SERVICE PROCEDURE

**G-10507
JUNE 2010**

**SUBJECT: SAFETY RECALL
SEAT BACK REINFORCEMENT ROD on certain CE
and RE model buses built 2/22/10 thru 3/16/10 with
passenger flip seat feature code 48UAH or 48UAU.**

1. **Seat back frame tube.**
2. **Reinforcement rod.**
3. **Retaining weld. Minimum 1/16" wide x 1/2" long.**

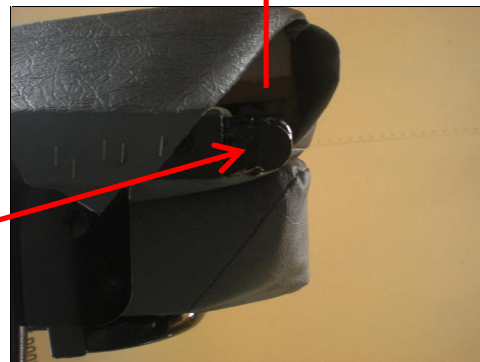
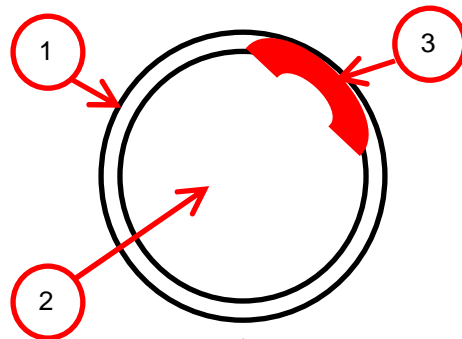
The weld that retains the reinforcement rod inside the flip seat back frame tube may fail allowing the rod to fall out of the frame. Without the reinforcement rod the strength of the seat may be reduced possibly increasing the risk of property damage, personal injury, or death in the event of a crash.

1. Overview: This procedure will involve the inspection of the reinforcement rod retaining welds and, if necessary, replacement of the seat frame.
2. Inspect the two reinforcement rod retaining welds on each flip seat on the bus.
 - a. Lie on the bus floor and look straight up at the corner of the flip seat back frame tube. The bottom of the reinforcement rod is not covered with upholstery but is recessed so a flashlight is needed for the inspection.
 - b. Inspect the length and width of the weld that retains the reinforcement rod in the flip seat back frame tube. At a minimum, the weld needs to be 1/16" wide and 1/2" long.

- c. Repeat the inspection procedure on the other reinforcement rod retaining weld located on the opposite side of the seat back.
3. If both welds are of sufficient length and width, no repair is required and service procedure is complete. If either weld is not sufficient, the seat frame will need to be replaced.

4. To replace the seat frame:
 - a. Remove the flip seat assembly from the bus by removing the floor mounting fasteners.
 - b. Remove the flip seat bottom subassembly from the seat and install it on the new frame.
 - c. Remove the seat back upholstery and foam from the frame and install it on the new frame.
 - d. Install the new flip seat assembly into the bus. Torque fasteners to 19-20 lb-ft.
